# PERMIT

## SEWAGE DISPOSAL SYSTEM

### HOWARD COUNTY HEALTH DEPARTMENT

SUBDIVISION Woodford's Grant LOT 12 ROAD 11346 Barley Field Way

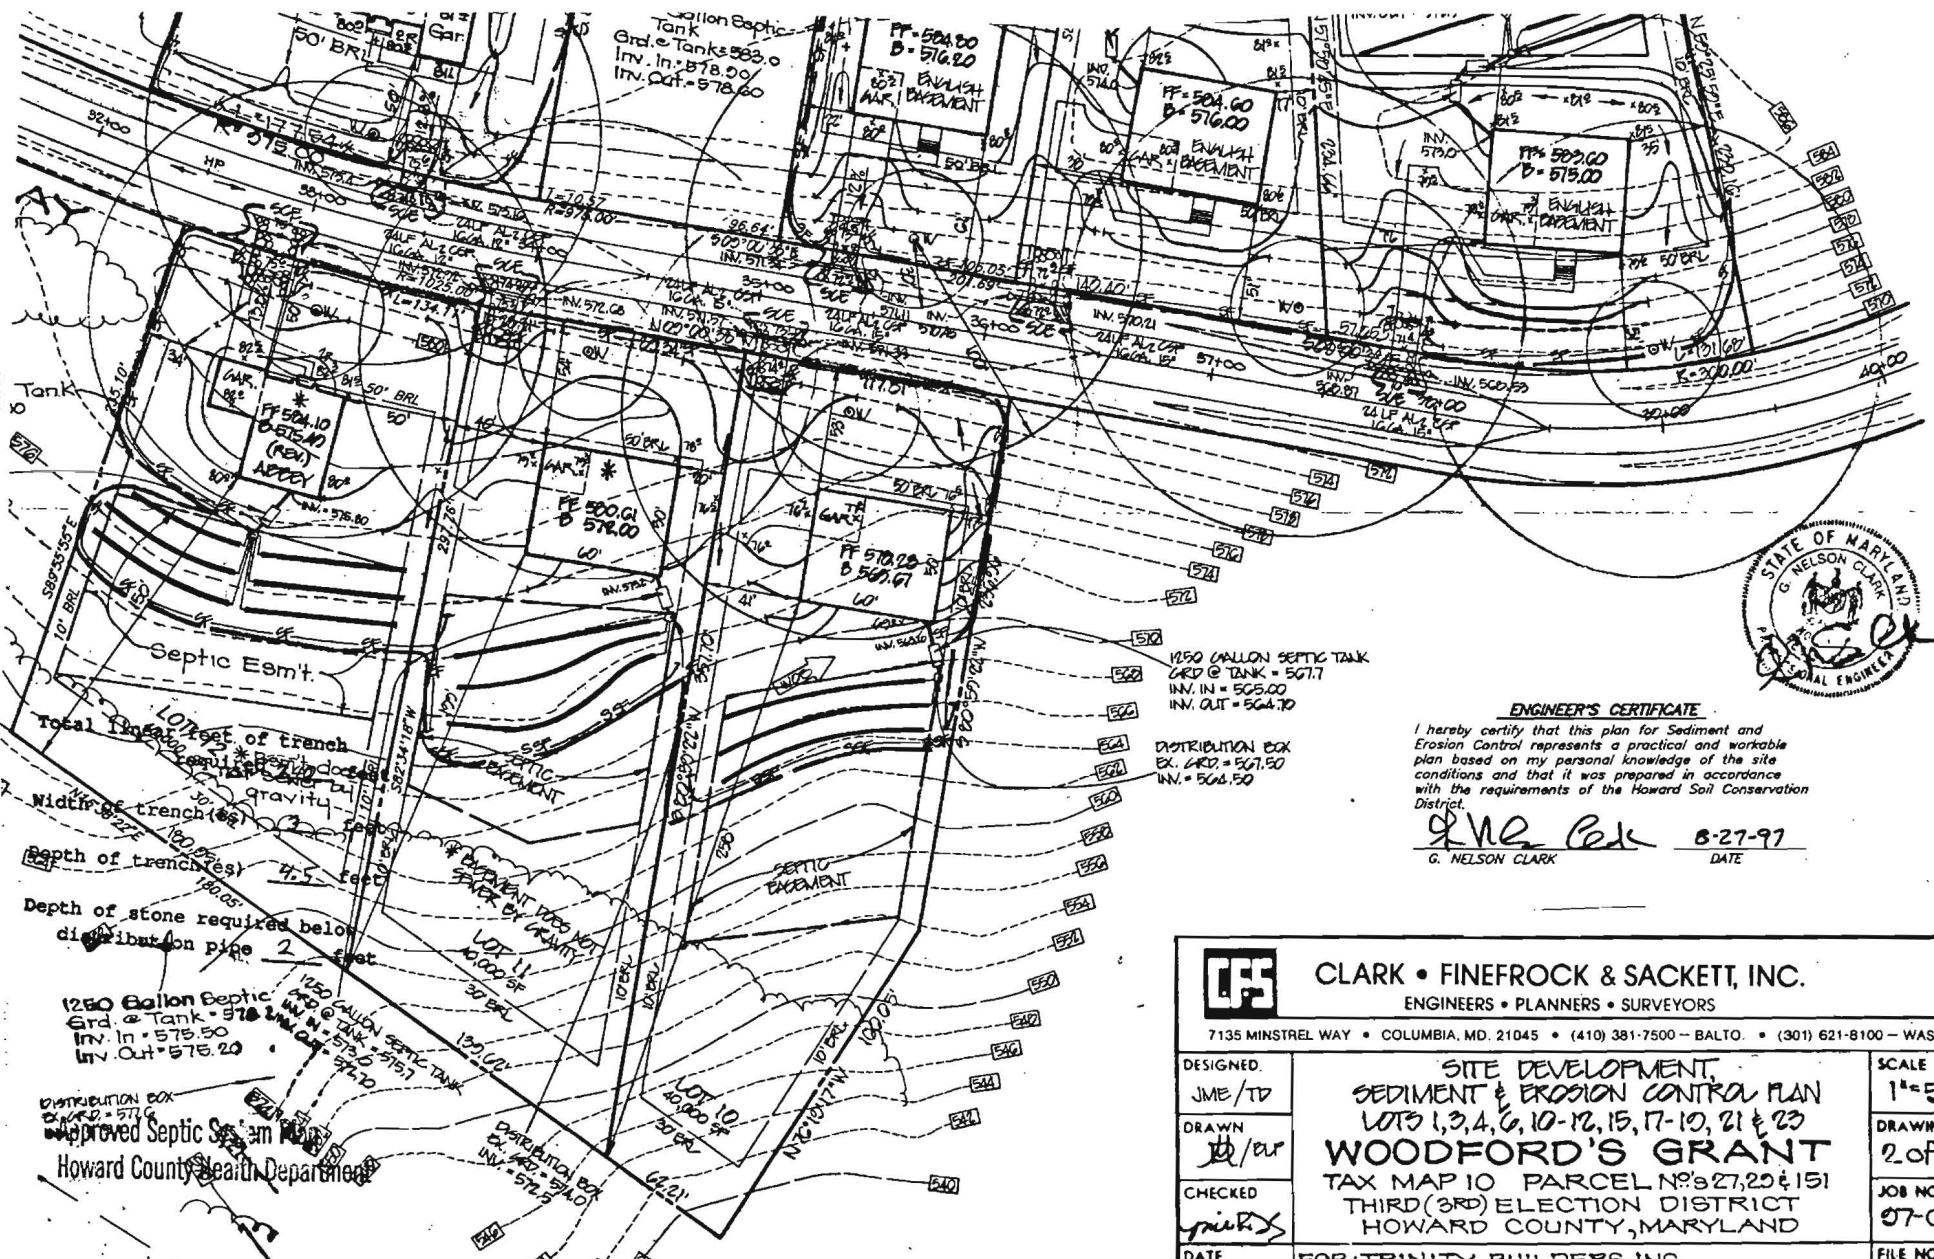
REMARKS: 12/22/97 OK to cover all work final. Although approved BP Plan shows ST. <100' from well - actual locations on-site maintain 100' separation ALM 1-13-97 Spoke w/ builder (Michael Phaf) about restrictions on deck due to tank location - max 4' wide deck) he acknowledged & proposed landing to deck to allow use of french doors above S.T. see --- above for proposal ALM

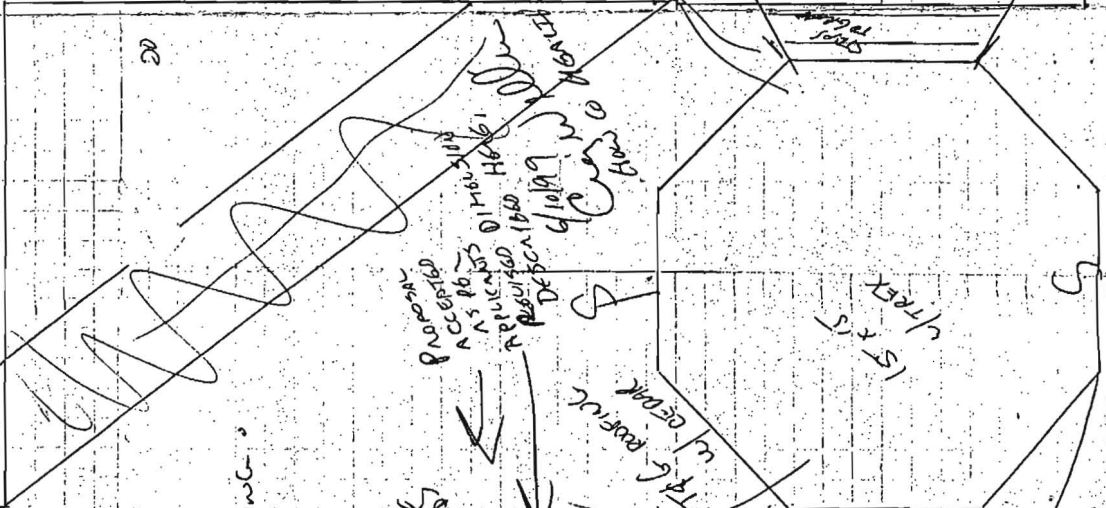
5/16/99  
 This deck  
 to drain field  
 15 19.0' - OK  
 to proceed as  
 shown - although  
 We do not regulate  
 pH - I suggest  
 not build it over  
 tank pool  
 good idea  
 I'd prefer  
 the pool  
 5/16/99
